STAFF REPORT

SUBJECT: FP-2021-0040
Landing No. 13

LOCATION: 660 S. Linder Rd., in the NW ¼ of
Section 13, Township 3N., Range 1W.

Final plat consisting of 8 buildable lots and 2 common lots on 2.43-acres of land in the R-4 zoning district.

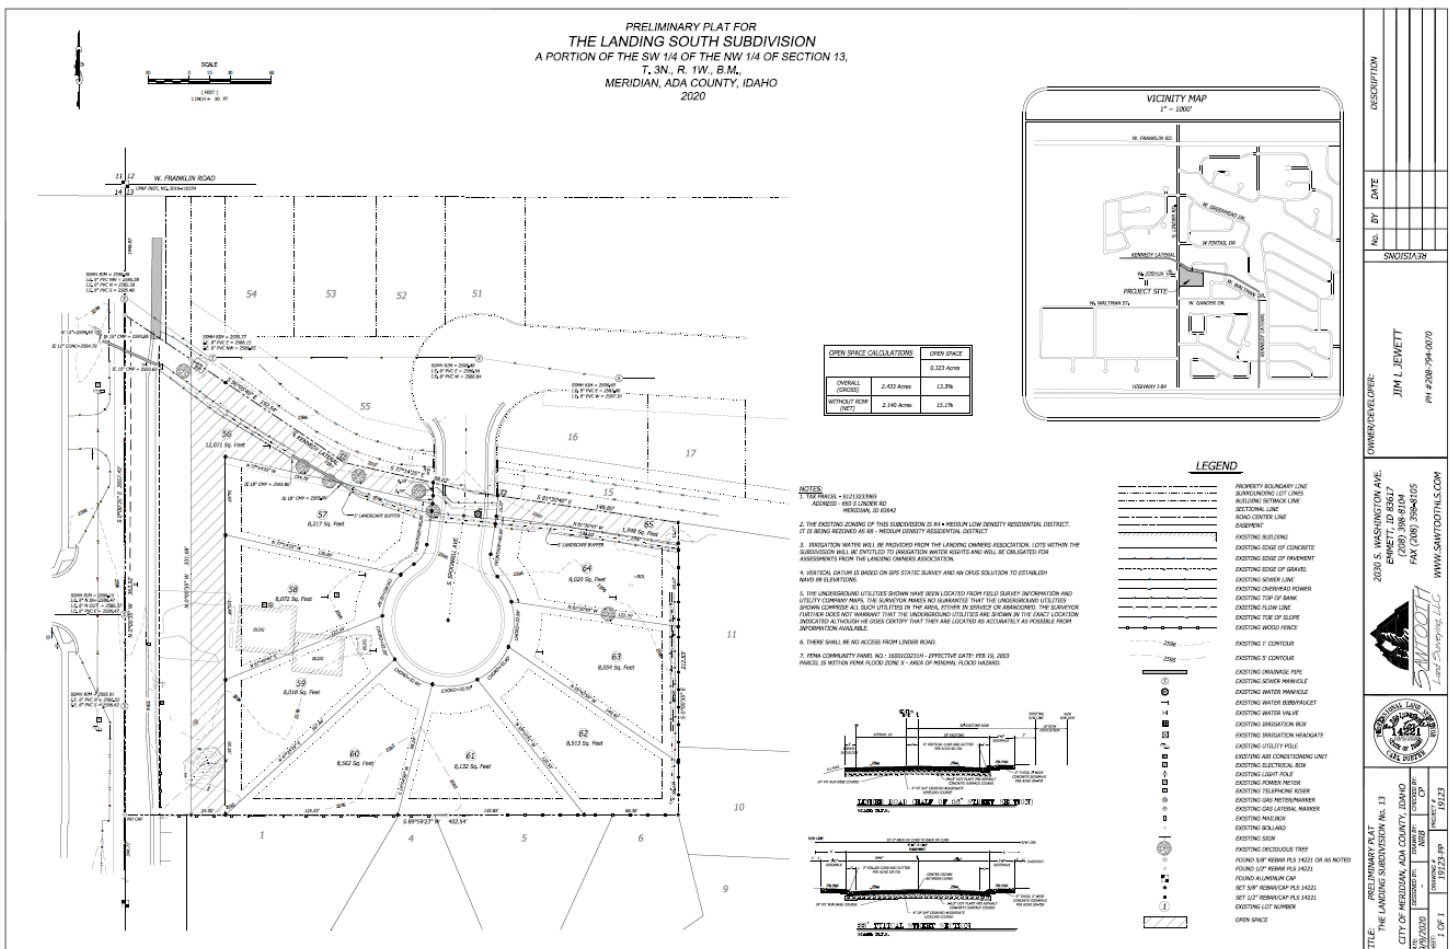
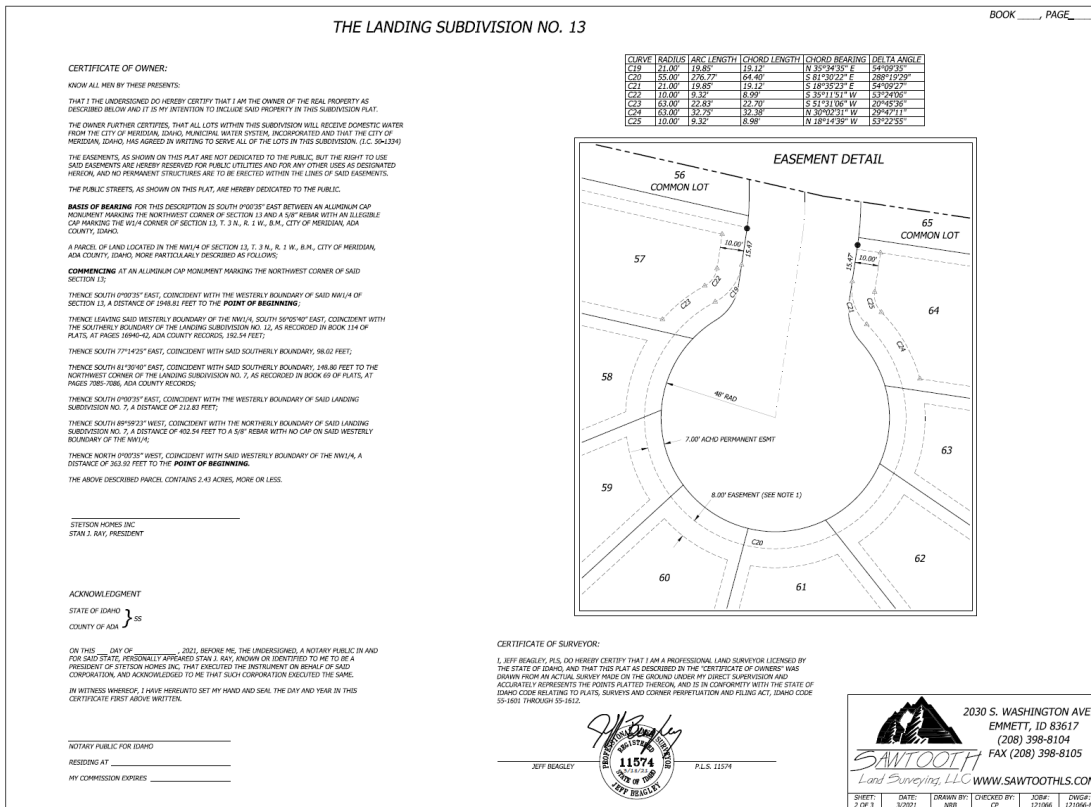
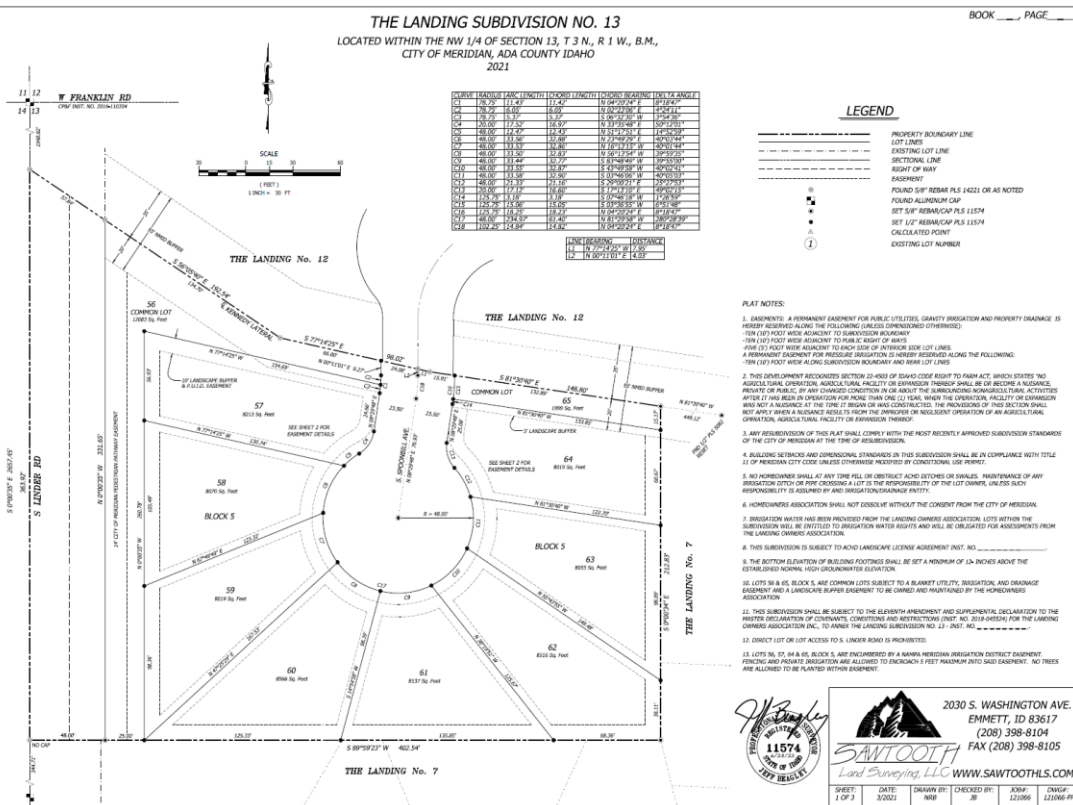
3. Prior to submittal for the City Engineer's signature, have the Certificate of Owners and the accompanying acknowledgement signed and notarized.
4. The final plat prepared by Sawtooth Land Surveying, LLC, stamped by Jeff Beagley, dated: 6/28/2021, included in Section V.B shall be revised as follows:

- a. Note #8: Include the recorded instrument number of the ACHD landscape license agreement.
 - b. Note #11: Include the recorded instrument number of the amended CC&R's.

- c. Remove the call-outs for the 10' and 5' landscape buffers on the north side of Lots 57 and 64, Block 5 as landscape buffers are not required in those locations, only along S. Linder Rd.

- d. Change the 55' NMID "buffer" to "easement" if it's an easement.

A copy of the revised plat shall be submitted for City Engineer signature.

C. Landscape Plan (dated: 06/14/2021)

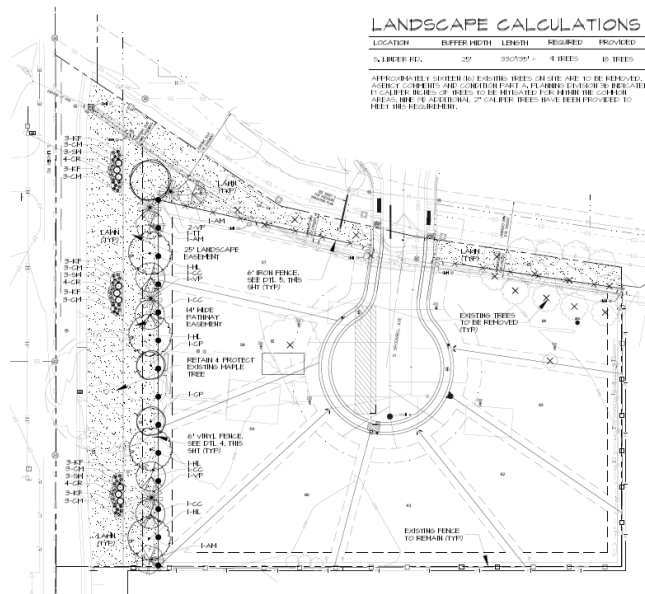
5. The landscape plan prepared by Jensen Belts Assoc., dated 06/14/2021, included in Section V.C, is approved as submitted.
6. A 14-foot wide public pedestrian easement for a future detached pathway along S. Linder Rd. is required to be submitted to the Planning Division with the final plat for City Engineer signature; coordinate the details of the easement with Kim Warren, Park's Department.
